# UNITED STATES PATENT AND TRADEMARK OFFICE

APPLICATION NO.	FILING DATE	FIRST NAMED INVENTOR	ATTORNEY DOCKET NO.	CONFIRMATION NO.
09/838,348	04/19/2001	Randall W. Ojanen	K-1786	2490

**Office Action Summary**

### DETAILED ACTION

FIG. 5

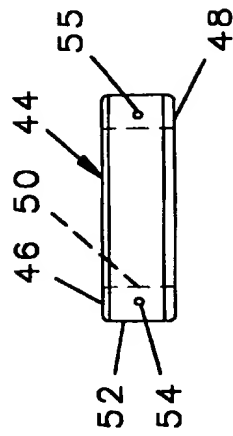
Steinke discloses a retainer sleeve (10) having at least one outwardly protruding surface/dimple (17, see col. 3 line 53), the retainer has a cylindrical circumference and a thickness dimension, it appears that the amount of radial projection of said protruding surface beyond the cylindrical surface of the retainer is about 15-30 percent of the thickness dimension of said retainer (see attached marked up Fig. 5).

FIG. 6

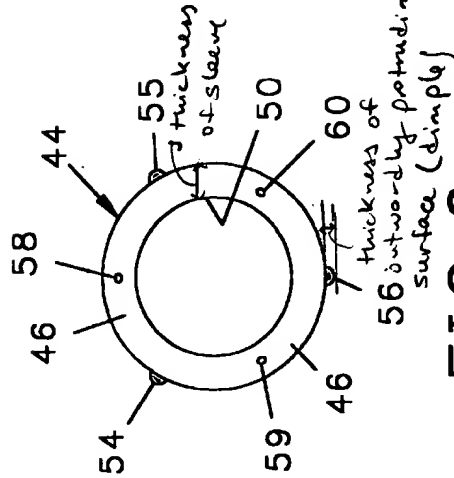
Sollami discloses a cutting tool assembly comprising a retainer sleeve (see Figs. 5,6), the retainer is cylindrical and has a thickness, the retainer sleeve includes at least one radially outward projecting dimple (54,55,56). The projection of the dimple(s) beyond the cylindrical surface of the retainer appears to be about 15-

30 percent of the thickness dimension of the retainer (see attached marked up Fig. 6).
